Appeal Hearing
SPA-2023-01543

Site Plan Approval Application
1591 Granville St and 1568 Hollis St, Halifax
Halifax Regional Council

SPA-2023-01543

Granville St. Elevation

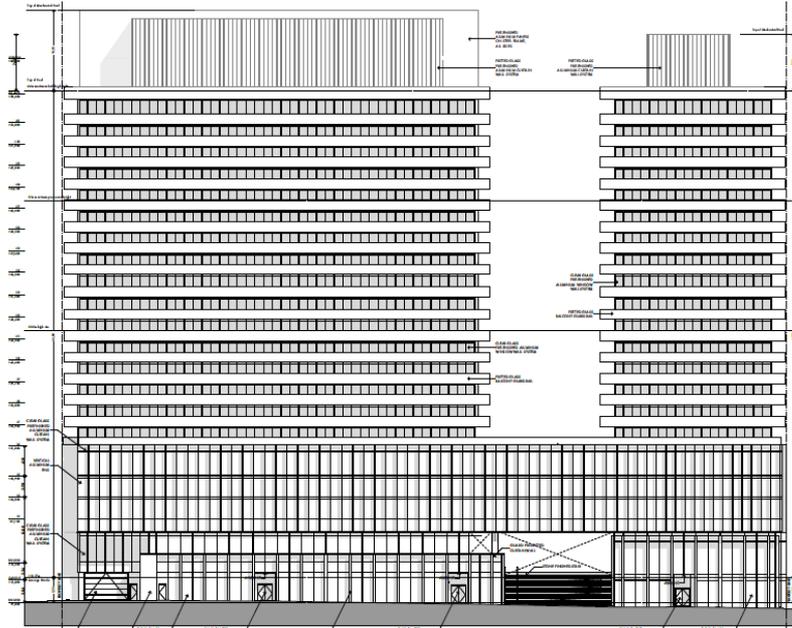
- Base of building – coincides with the streetwall and displays a high degree of transparency and quality materials;
- Middle – clearly distinguished from the base as the towers are horizontal in their articulation as a result of the repetition of the continuous balconies that wrap around the towers;
- Top - The south tower top is clearly distinguishable from the middle. However, the north tower top lacks interest and distinguishing characteristics and does not contribute to the visual quality of the skyline.

Overall – the “top” of the north tower does not meet the requirements of the Design Manual

Variance – Streetwall Stepback

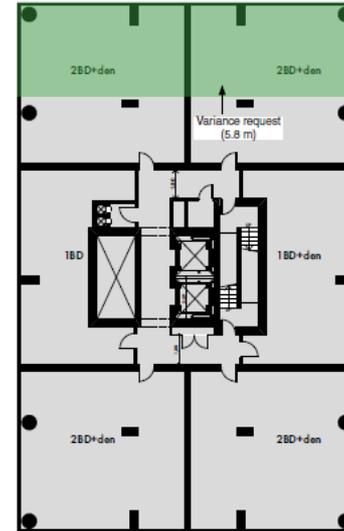
- Proposed reduction in required streetwall setbacks:
 - for the north tower, from 3m (mid-rise) and 4.5m (high-rise) setback to 2m and 1.5m at various locations.
 - for the south tower, from 3m (mid-rise) and 4.5m (high-rise) setback to 2.62m for the south tower
 - balconies will have no setbacks
- Refusal based on the following:
 - inconsistent with the built form (base/ middle/ top) objectives of the DHSMPS, LUB and DM;
 - north tower is needlessly close to all abutting streets;
 - south tower is located too close to Hollis Street and too far away from Granville St.;
 - there is no resulting “positive benefit”. A redesign with alternate floor plates could resolve variance issues

Variance – Tower Width and Separation

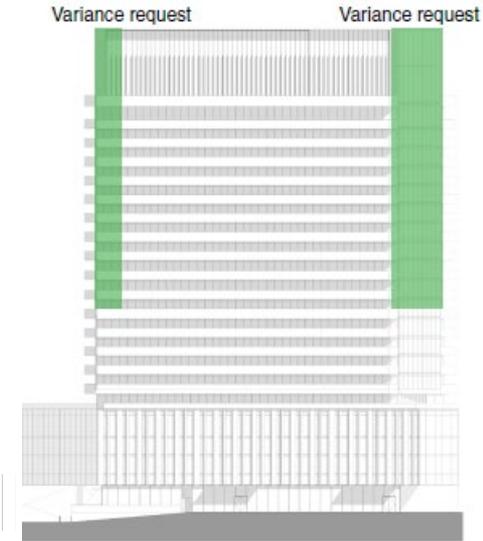
- **North Tower:** Proposed tower depth increase of 5.8m
- **South Tower:** Proposed tower width of ~54m (~57m with balconies incl.) instead of 38m & Proposed separation distance of 18.9m (15.3m with balconies) instead of 23m;
- Refusal as the increased south tower width directly results in an undesirable separation distance between the north and south towers. In addition, the large width of the south tower goes against the Plan's objectives of providing sunlight penetration and sky view at street level.
